H11862

OPR-G347-NRT2-08

**HYDROGRAPHIC SURVEY
H11862**

B. DATA ACQUISITION AND PROCESSING *See also the Evaluation Report*

Figure 1.1.1

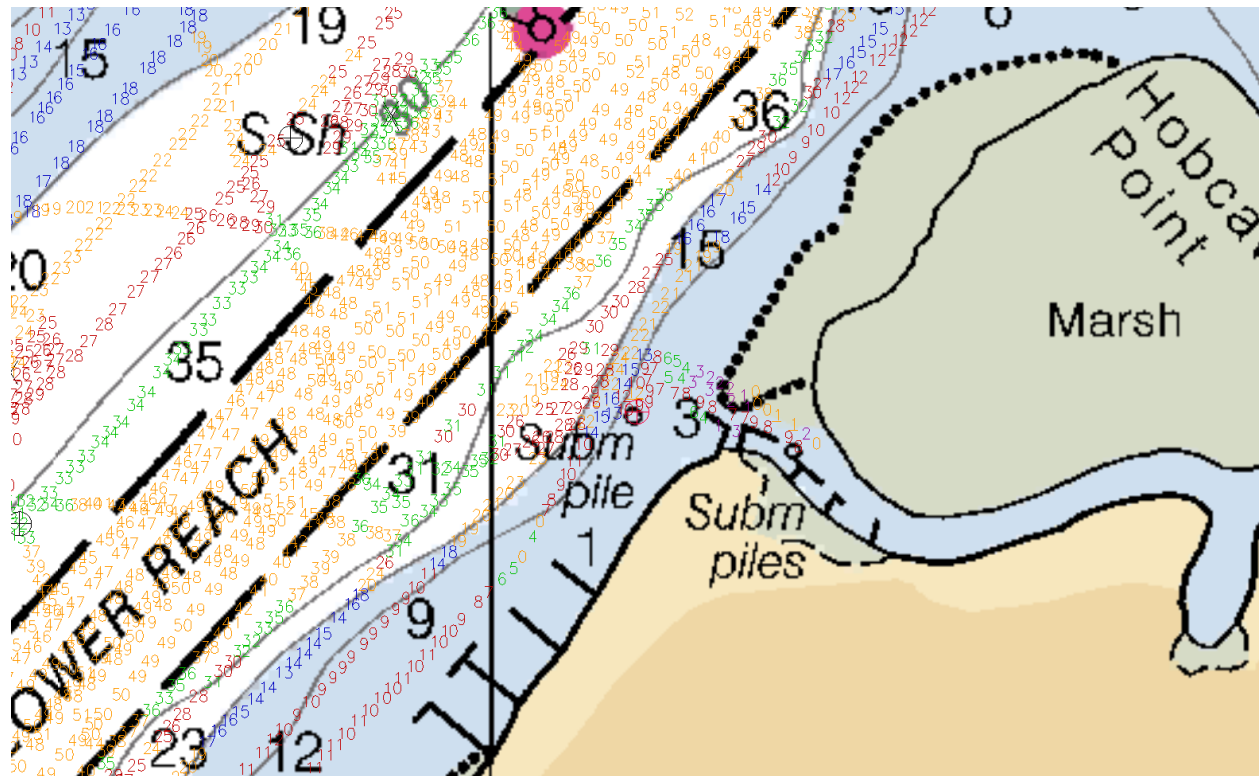
Visually identified private no-wake sign baring, at charted position of subm pile. The subm pile note should be removed from the charts, and a charted Private Marker should be added.

Remove subm pile, and chart Private Marker.

AHB concurs w/ the field. The Sign is displayed on the current edition of the raster chart but a subm pile is shown on the ENC. The ENC should be updated; the note revised to Sign no changes to charting of the symbol necessary.

Figure 1.1.1

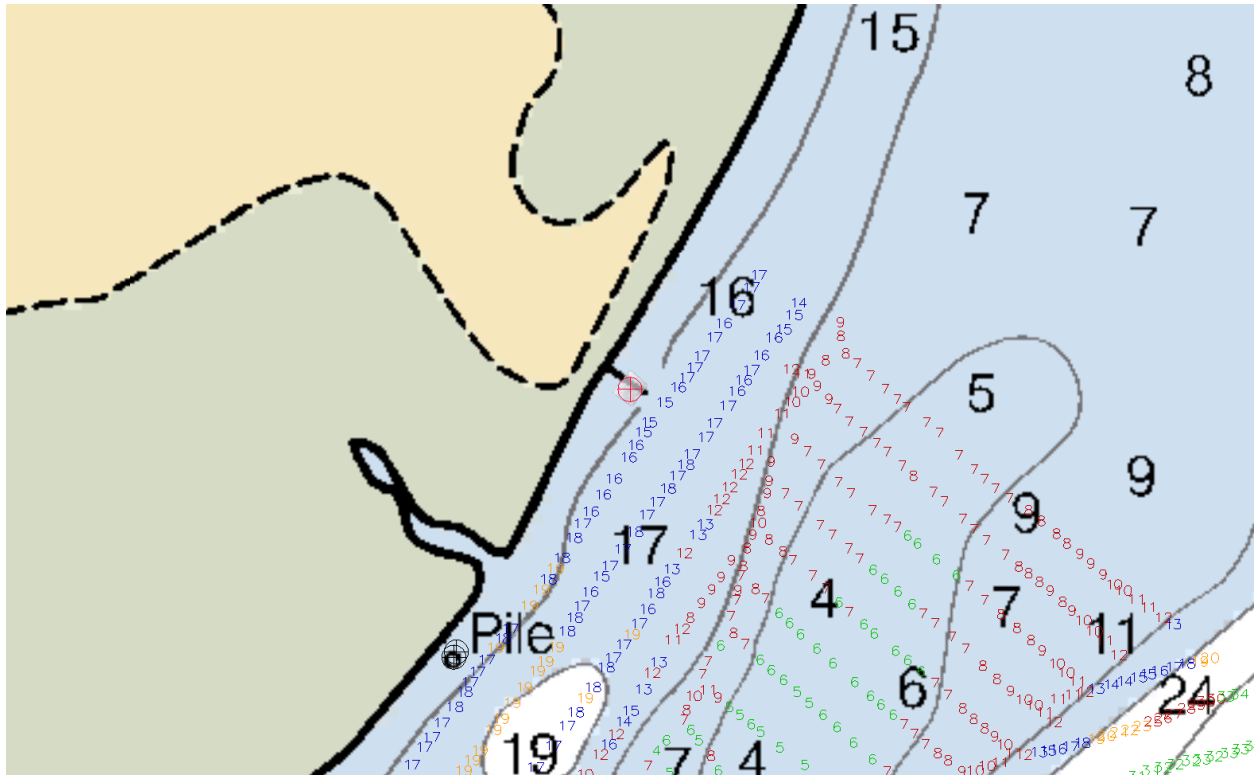
Revise the charted pier to ruins on the .

AHB concurs w/ the field. Pier considered disproved by side scan records. Revise charted pier from the raster and ENC to pier ruins.

1.4) Delete 14-ft rep (2005) NOTE

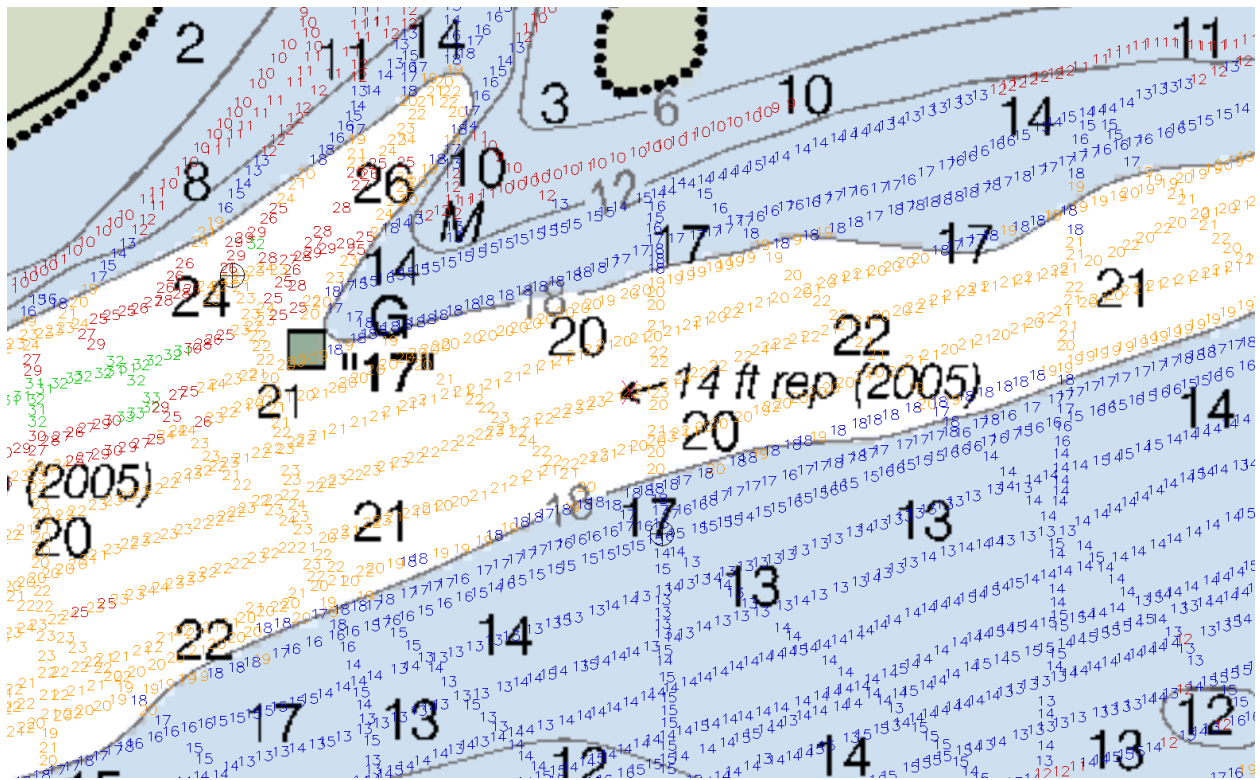
Remove chart note "14 ft rep (2005). Apply survey soundings.

AHB concurs w/ the field. Recommend to delete charted 14ft rep (2005) notation and update area with present survey depths.

1.5) Delete 13-ft Rep (2005)

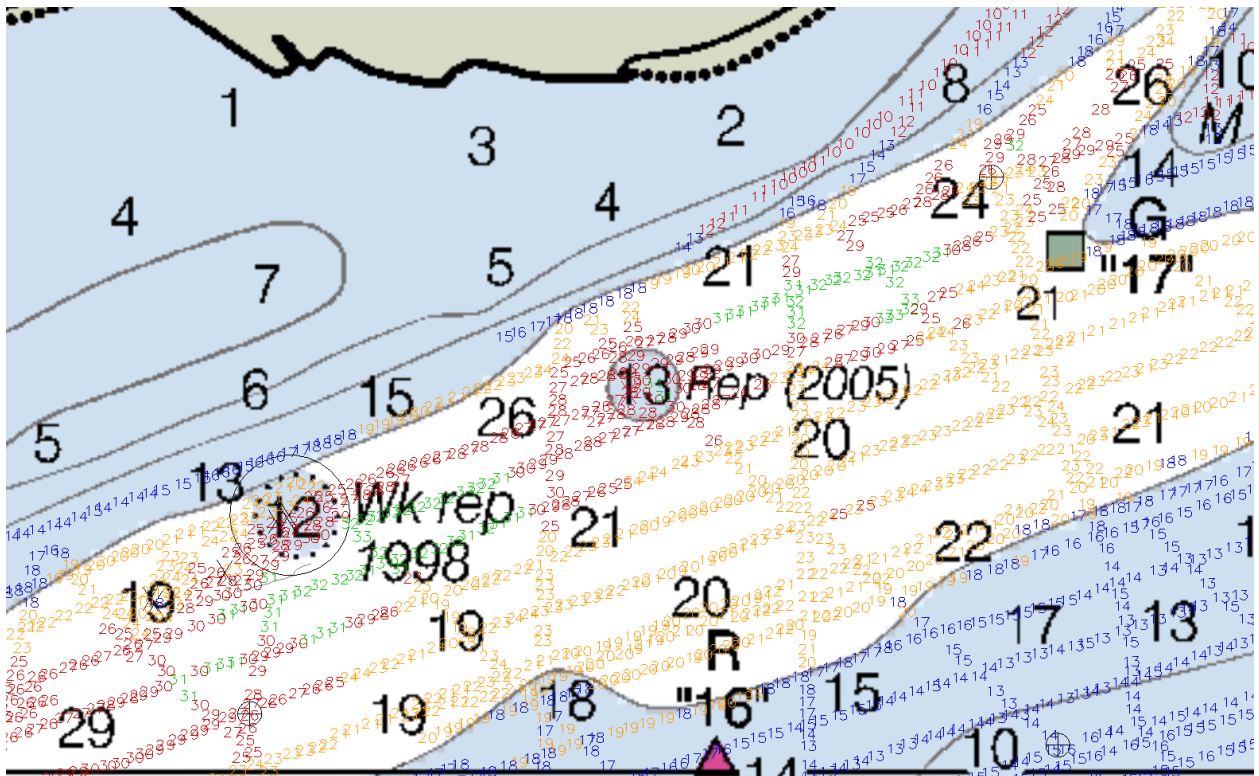
Remove 13 ft isolated sounding REP, and apply survey soundings in area.

Concur. Delete 13 ft depth and Rep (2005) note and update chart with present survey depths.

1.11) Delete 3-ft Rep (2005)

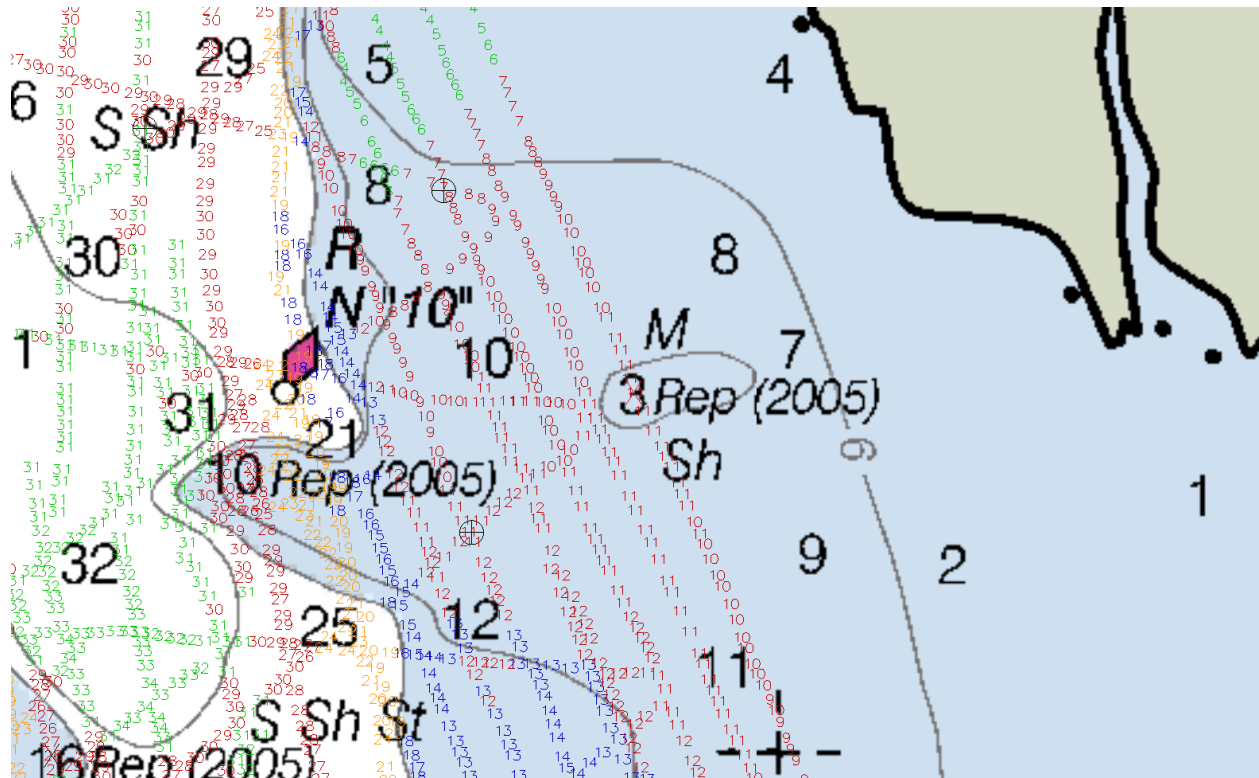
Remove charted 3ft REP, and apply survey soundings.

AHB concurs w/ the field. Delete charted 3-ft Rep (2005) note and update with present survey depths.

1.12) Delete 10-ft Rep (2005)

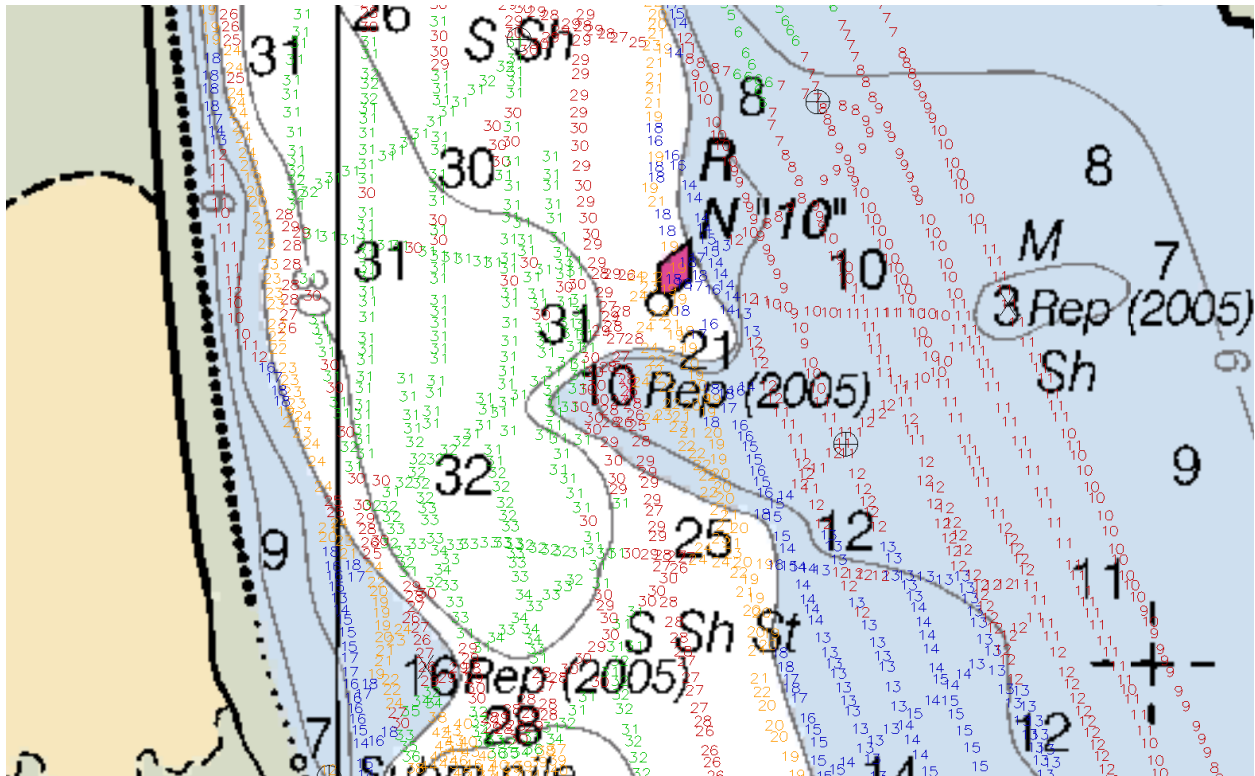
Development of this contour extension into the channel, and the 10 ft Rep (2005) show no such sounding exist as well as the contours need to be changed to match the survey sounding data.

Remove the 10ft Rep , and apply the survey sounding data.

AHB concurs w/ the field. Delete charted 10-ft Rep (2005) note. Update the chart with present survey depths.

1.13) Delete 16 Rep (2005)

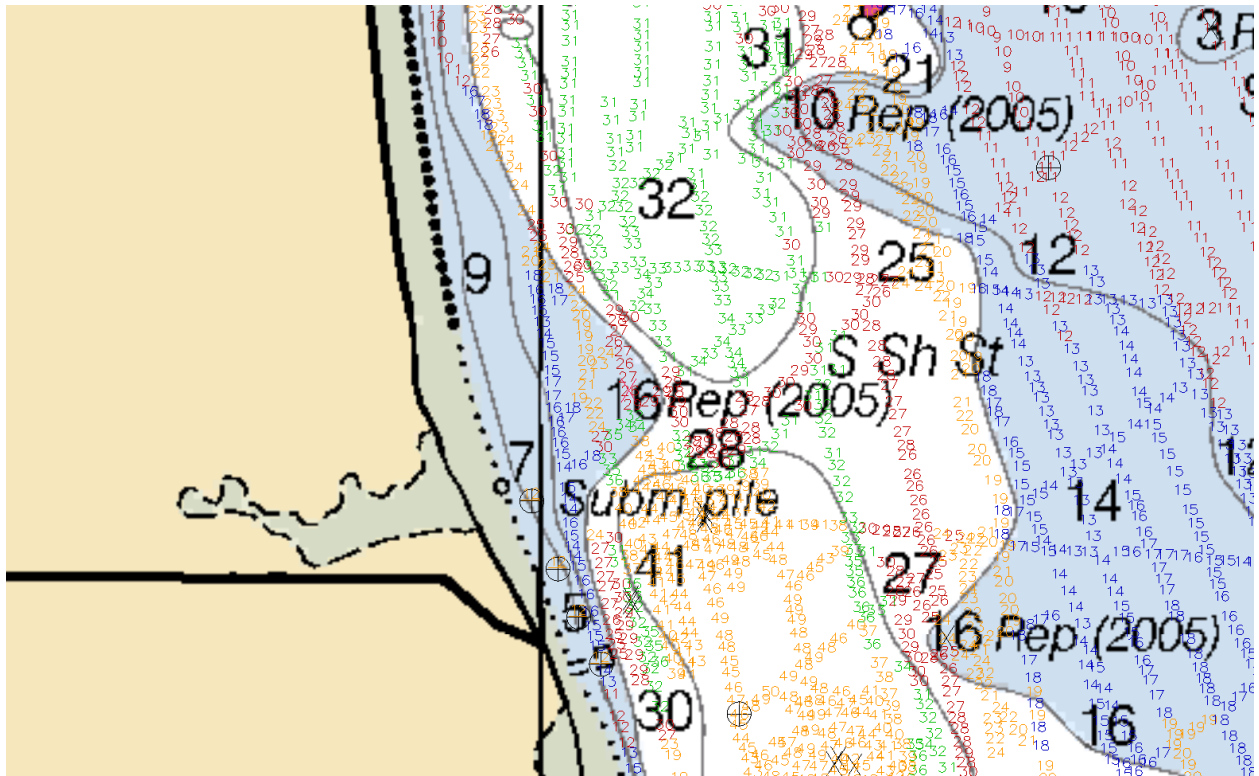
Remove the 16ft Rep, and add survey soundings in area.

AHB concurs w/ the field. Delete charted 16-ft Rep (2005) note. Update area with present survey depths.

1.14) Delete 16 Rep (2005)

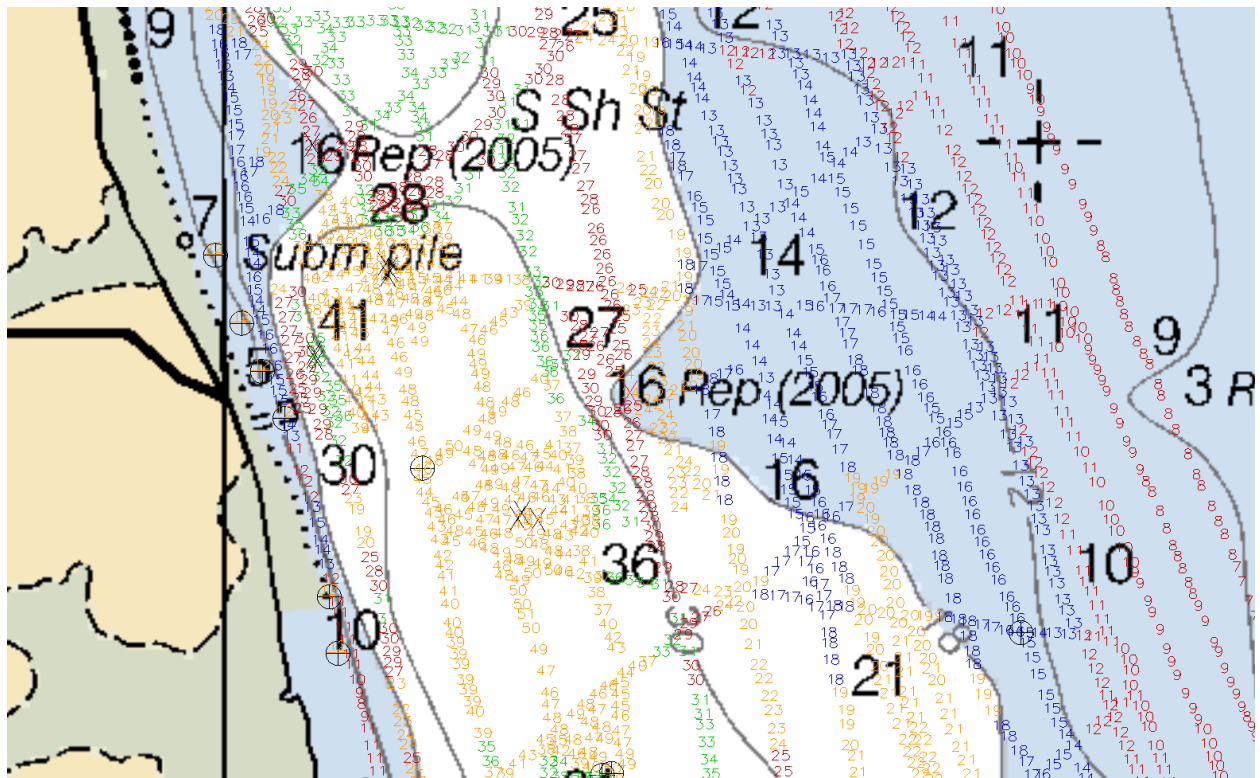
Remove 16 ft Rep and apply survey soundings.

AHB concurs w/ the field. Delete charted 16-ft Rep (2005) note. Update area with present survey depths.
